RAI Volume 3, Chapter 2.2.1.3.6, First Set, Number 2:

Explain how the TSPA seepage conceptualization and abstraction are consistent with observations and interpretations of the presence of liquid water in the Passive Test in the Enhanced Characterization of the Repository Block (ECRB) drift.

Figure 1. Profiles of Evaporation (Condensation) Rate with Position in Emplacement Drift #7 from Condensation Model, Including Unheated Ends of Drift, at 1,000 Years after Closure

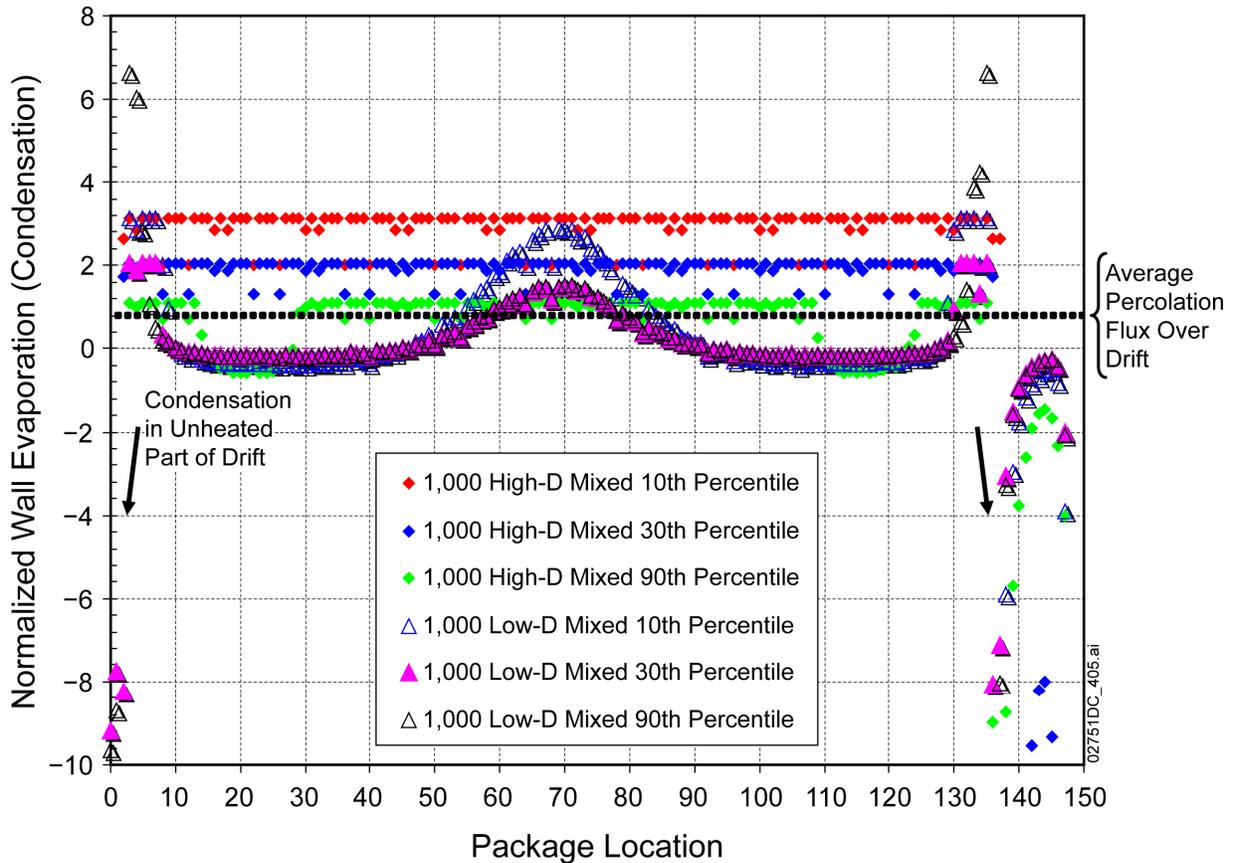
Explain how the volume of water entering a drift is not underestimated by the TSPA seepage abstraction, which neglects vapor migration into the drifts through fractures or other air pathways, redistribution within the drift, and subsequent condensation. See related RAI from Scenario Chapter, Set 5, RAI #3. This information is needed to verify compliance with 10 CFR 63.114(a), (c), (e), and (g).

Drift-wall condensation occurs only for the 1,000-year case used for the TSPA (SAR Section 2.3.5.4.2.4), which is applied during the final cooling stage, but only from when the drift wall cools below boiling until 2,000 years after closure. During this period, evaporation occurs near the center of each emplacement drift, and condensation occurs closer to the ends (example results for Drift #7 from the model are plotted in Figure 1). Importantly, for the 1,000-year case, when drift-wall condensation can occur, the rate of evaporation from the drift wall exceeds the incident percolation flux, because of the capillary pumping feature of the condensation model (SNL 2007, Section 6.3.5.1.4). This is shown by evaporation rates that exceed unity, when normalized by the average percolation incident on the drift (Figures 1 and 2). The drift opening captures as much as two to three times as much flux as that incident on the opening footprint, particularly when drift-wall condensation is strongest (Figure 1). Further, open rockbolt boreholes would access rock that is at a lower temperature, and would therefore tend to decrease humidity at the drift wall during the thermal period, which may lead to liquid/vapor reflux in these open boreholes. However, as discussed in the response to RAI 3.2.2.1.3.6-003, vapor/liquid reflux during the thermal period has little effect on seepage. Thus, while the condensation model does not explicitly account for open rockbolt boreholes, it captures percolation from a distance comparable to or greater than the reach of rock bolt boreholes, when evaporation is active near the center of each drift. The occurrence of drift wall condensation during this period, as predicted by the condensation model for the 1,000-year case, is included in the TSPA and treated as seepage (SNL 2008, Section 6.3.3.2).

Figure 1 Distribution of Quantile Position of Average Seepage per Percolation Subregion at (a) 10,000 Years and (b) 1,000,000 Years after Closure

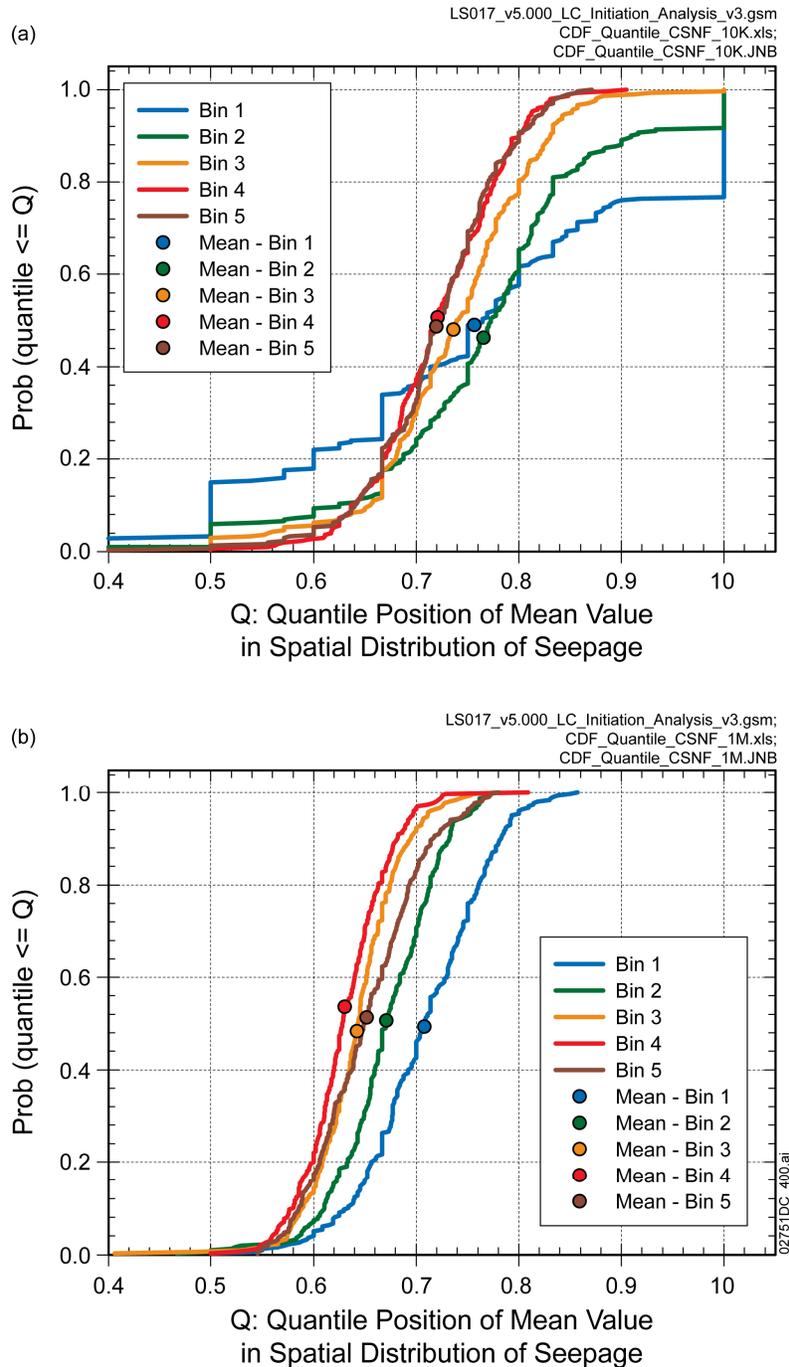
Explain how averaging seepage rates from individual waste package locations to create representative seepage rates for each percolation subregion impacts EBS radionuclide releases and doses. In addition, provide the technical basis for the assumption that five percolation subregions are sufficient to represent seepage and EBS release variability over the repository footprint. Consideration should be given to both the nominal and seismic ground motion scenarios. This information is needed to verify compliance with 10 CFR 63.114(b).

The spatial variability of seepage within each percolation subregion is summarized by the results presented in Figure 1, which shows CDFs of the quantile position of the average seepage rate within the spatial distribution of seepage. This probabilistic analysis considers an epistemic sample of size 300, as was used in the model. Figure 1 was made by calculating the seepage rate at 100 randomly selected MSTHM subdomain locations in each percolation subregion. For each sample element, the quantile position of the average seepage rate within the spatial distribution of seepage rate (for subdomain locations experiencing seepage rate greater than the threshold value of 0.1 kg/yr per waste package as described in SNL 2008a, Section 6.3.3.1.3) was calculated for each percolation subregion, and the distribution of these quantiles (over the epistemic sample) is shown in Figure 1. For all values of this distribution higher than 0.5, the spatial distribution of seepage is skewed to the right. Figure 1(a) shows that for 10,000 years after closure, the quantile position of the average seepage rate is above 0.5 in all subregions for

most epistemic sample elements; thus, the local seepage rate at most waste package locations in each subregion is less than the average seepage rate. A similar conclusion holds for 1,000,000 years after closure, as displayed in Figure 1(b).

Figure 1. Correlation between Seepage Fraction and Expected Annual Dose at (a) 10,000 Years and (b) 1,000,000 Years for the Seismic Ground Motion Modeling Case

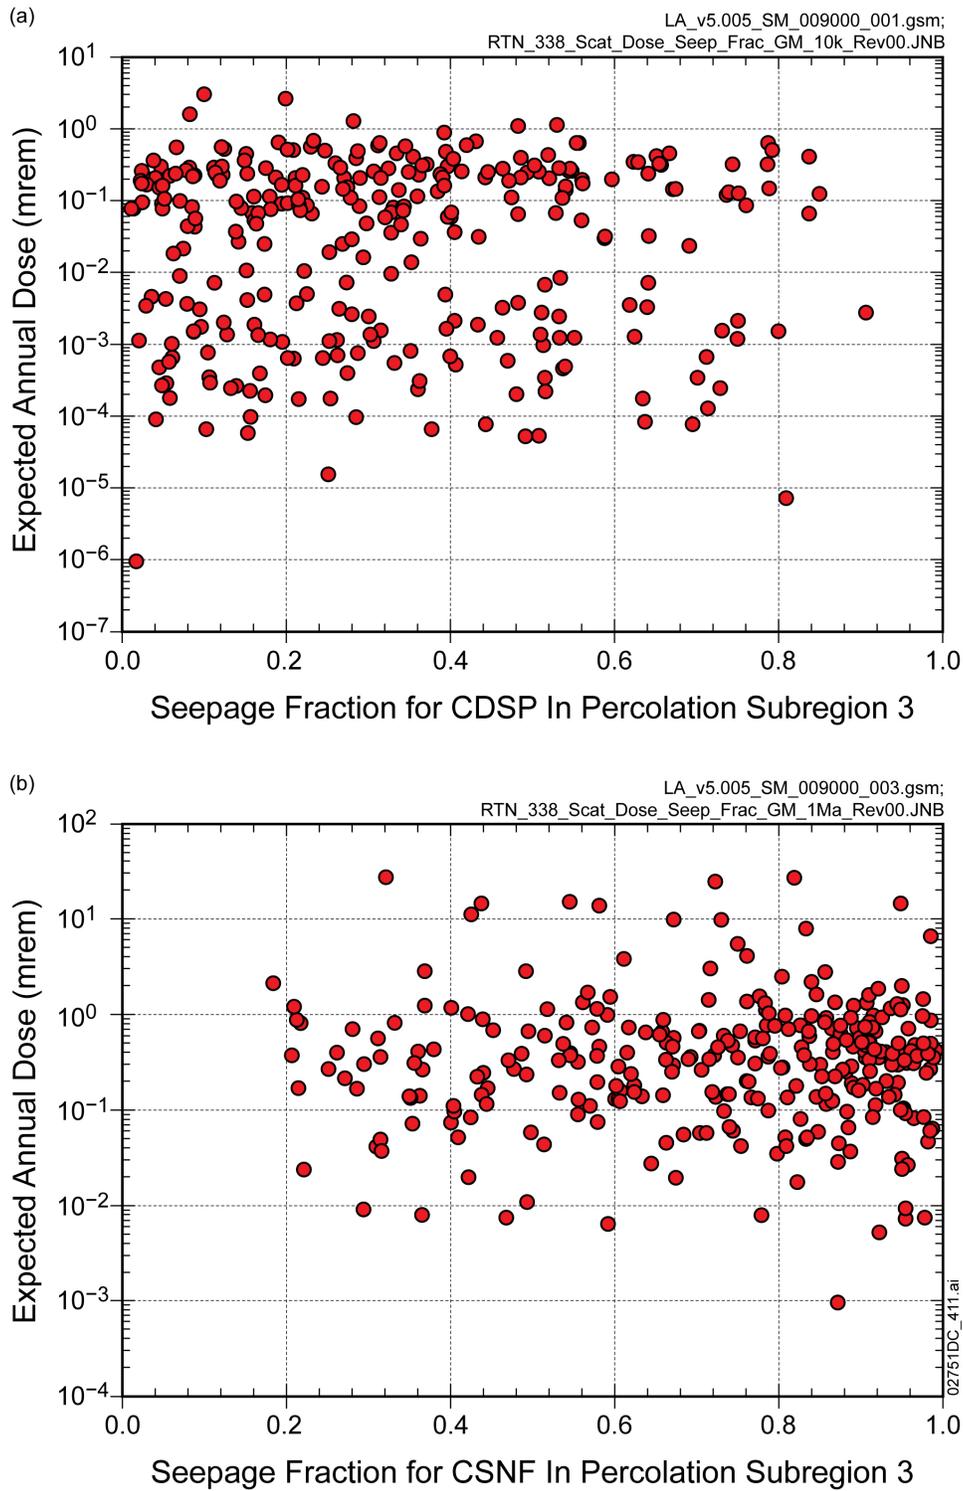
Also, spatial variability may be under represented, even if the two dimensional model appropriately characterizes flow in the TSw, when variability in flow at the base of the PTn is not fully considered. The model uses top boundary conditions that are either uniform or have regularly spaced sources. SNL (2007, Figure 6.6 13) suggests that fluxes calculated by the two dimensional model remain coherent at scales on the order of 10 to 20 m [33 to 66 ft], which can be interpreted as implying that flow variability at the base of the PTn at spatial scales as small as 10 m [33 ft] may increase flow variability at the drift scale. Several mechanisms may result in flow variability at this scale, such as (i) localized infiltration, (ii) local heterogeneity in the PTn, and (iii) episodic flow focusing into widely

The lack of sensitivity of repository performance to uncertainty in seepage fraction is demonstrated by Figure 1. Figure 1a shows the relationship between seepage fraction for codisposal waste packages in percolation subregion 3 and expected annual dose at 10,000 years for the seismic ground motion modeling case. As discussed in SAR Section 2.4.2.2.1.1.2, total mean dose to the reasonably maximally exposed individual (RMEI) for 10,000 years after permanent closure is dominated by contributions from the seismic ground motion modeling case, and this dose results from seismic damage to codisposal waste packages. For this demonstration, seepage fractions from percolation subregion 3 are selected, because this subregion comprises 40% of the waste packages in the repository. The variability in both seepage fraction and expected annual dose on Figure 1a results from epistemic uncertainty, because the expected annual dose has been integrated over aleatory uncertainty in seismic events. The lack of any correlation between seepage fraction and expected annual dose demonstrates that the mean annual dose for 10,000 years after permanent closure is not sensitive to the spatial variability in seepage represented by the seepage fraction. Rather, the uncertainty in the expected annual dose is dominated by epistemic uncertainty in the residual stress threshold for Alloy 22 (SAR Section 2.4.2.3.3.6), with minor sensitivities to other uncertain inputs (SAR Figure 2.4-149). Examination of other percolation subregions would reach a similar conclusion because the uncertainty in expected annual dose is not strongly influenced by uncertainty in quantities that vary between the percolation subregions (i.e., seepage fraction). Moreover, the results shown in Figure 1a cover most of the range of seepage fraction (nearly 0 to greater than 0.8) that is observed in the other percolation subregions.

Figure 1b shows the relationship between seepage fraction for commercial SNF waste packages in percolation subregion 3 and expected annual dose at 1,000,000 years for the seismic ground motion modeling case (which includes the effects of nominal processes). As discussed in SAR Section 2.4.2.2.1.1.2, total mean dose to the RMEI at 1,000,000 years after permanent closure results is comprised of roughly equal contributions from the seismic ground motion modeling case (which uses the seepage abstraction) and the igneous intrusion modeling case (which does not use the seepage abstraction). Moreover, in the seismic ground motion modeling case, the expected annual dose after about 500,000 years after permanent closure is dominated by releases from commercial SNF waste packages, which in turn results primarily from waste package failures associated with nominal processes. The lack of any correlation between seepage fraction and expected annual dose demonstrates that the mean annual dose at 1,000,000 years after permanent closure is not sensitive to the spatial variability in seepage represented by the seepage fraction. Rather, the uncertainty in the expected annual dose is dominated by epistemic uncertainty in the temperature dependence coefficient associated with the general corrosion rate for Alloy 22 (SAR Section 2.4.2.3.3.6), with minor sensitivities to other uncertain inputs (SAR Figure 2.4-151).

Figure 1. Comparison of the Cumulative Distribution Functions of Spatially-Averaged Percolation Rate per Commercial SNF Waste Package during the Glacial-Transition Climate for the GLUE-weighted and Unweighted Analyses

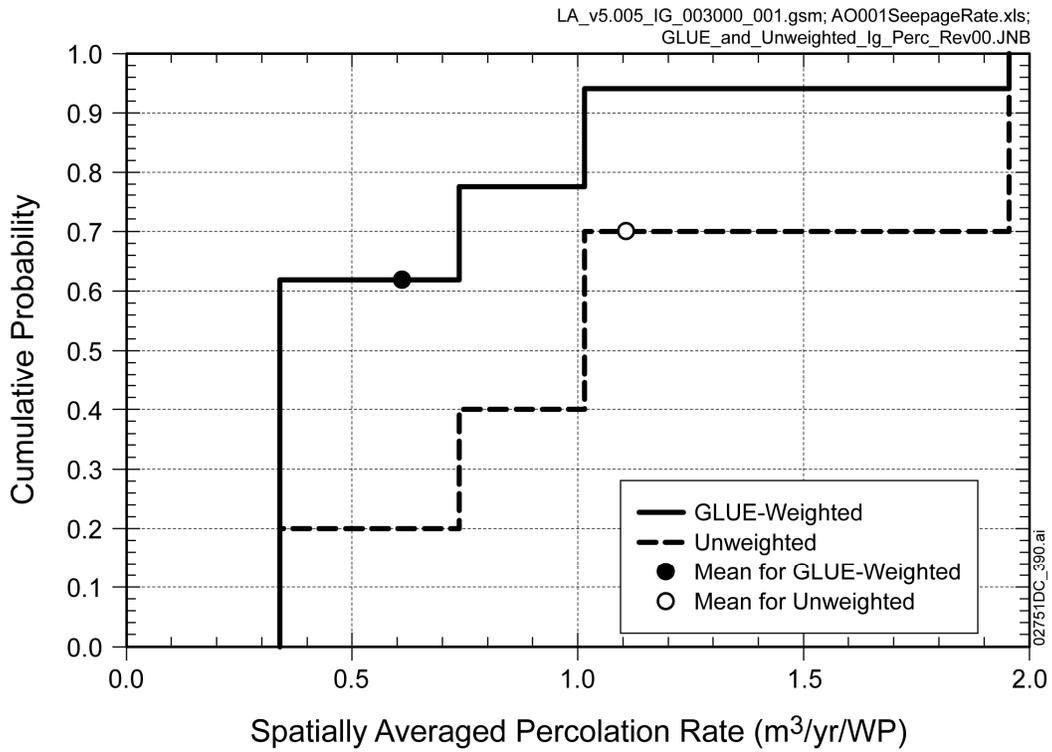
Basis: The GLUE procedure results in a set of weights applied to the infiltration scenarios (SAR Section 2.3.2.4.1.2.4.5.5). These weights yield lower expected mean annual infiltration than the original weights provided in SNL (2008). The SAR and supporting documents do not clearly describe how performance changes when the infiltration scenario weights are modified using the GLUE procedure. Therefore, it is not possible to evaluate the effects of the GLUE-derived weights on seepage, release, and transport.

The unweighted case results in higher likelihood of larger values of *INFIL* (Table 1), which corresponds to greater mean annual net infiltration, and consequently higher likelihood of greater average percolation flux. Figure 1 compares the distributions for the repository average percolation rate per waste package during the glacial-transition climate for the GLUE-weighted and unweighted analyses. Each distribution shown on Figure 1 consists of four discrete values because these results have been averaged spatially within each percolation subregion and over the five percolation subregions. The uncertainty in these results arises only from the selection of the infiltration case. Higher percolation rates are more likely in the unweighted analysis, which leads to an increase in the mean repository average percolation per waste package during the glacial-transition climate by a factor of about 80%, from 0.61 to 1.1 m³/yr. For all climate states, Table 2 shows the increase in mean percolation flux at the base of the Paintbrush nonwelded (PTn) unit over the repository footprint resulting from the use of unweighted distribution for *INFIL*. Note that the average infiltration fluxes (Section 1.1) and percolation fluxes (Table 2) over the repository footprint are not necessarily equal because of the following three factors:
